Type Coffee Vending Machine	Model FB55 - 7100 Plus - 7100 (ES/FB/IN/B2C) - CV7200/7300 - 7300 - 7600	T.I. NO 01 - 2016	
Serial Number See table included	Subject NEW POSTER Jacobs Douwe Egberts	ISSUED FOR (X)	Action Information X

A new brand has been defined for all the Douwe Egberts markets, so a new Poster has been introduced. Below a picture of the **old** “Poster Frame” made by a **single graphic panel**.

Poster Frame - Current situation ONLY for The Netherlands
This picture refers to a Gallery 220

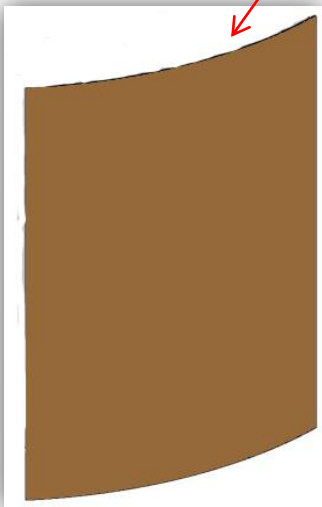
Poster JDE:
single graphic panel
Old graphic

The poster material is different from the previous one, because the old poster (PVC treated) was in direct contact with the final user in front of the machine.

Poster Frame - New situation
 This picture refers to a CFT 2100

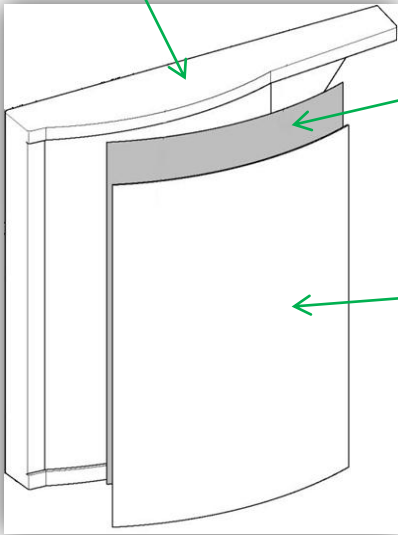
The **new** Poster “**Black background and smoke JDE**” is no longer a single graphic panel, but it’s a **sandwich made of two pieces**, directly mounted in the door of the machines above mentioned.

New “**Poster Frame Assembly**”: Poster Frame + a Sandwich made by:
 - Poster Standard JDE (**new graphic**)
 - Poster Panel Glass (**new material**)

Poster Standard JDE
New graphic

Poster Panel Glass
New material

Gallery 420

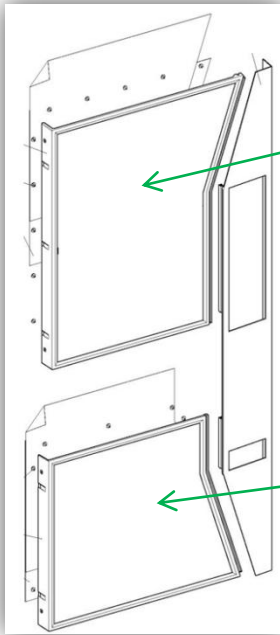
New poster black smoke upper part: new graphic panel (new spare code)

Poster black smoke lower part: the spare code is not changed
